**NUMBER:** 17-002-10 REV. A

**GROUP:** Rear Suspension

Rear Shock Buzz / Squeak / Rattle

2011 (WK) Grand Cherokee

**Fig. 1 Yellow Paint Mark**

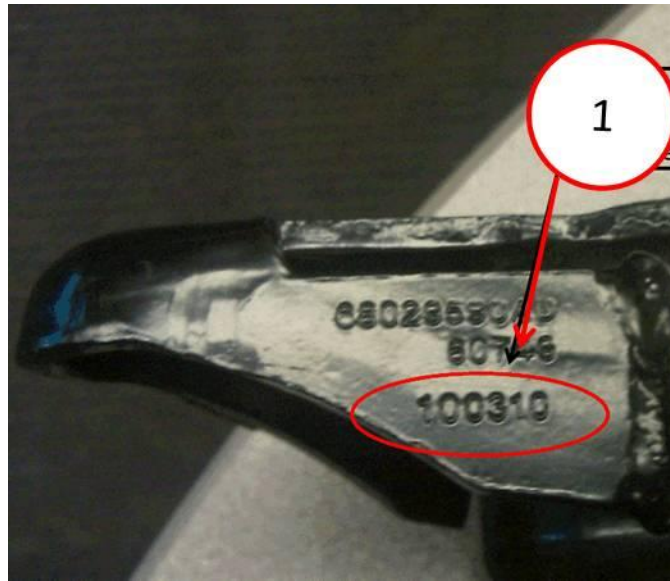
**NOTE: Modified part stock will have yellow paint marks (Figure 1) or include a September or later date code (Figure 2).**
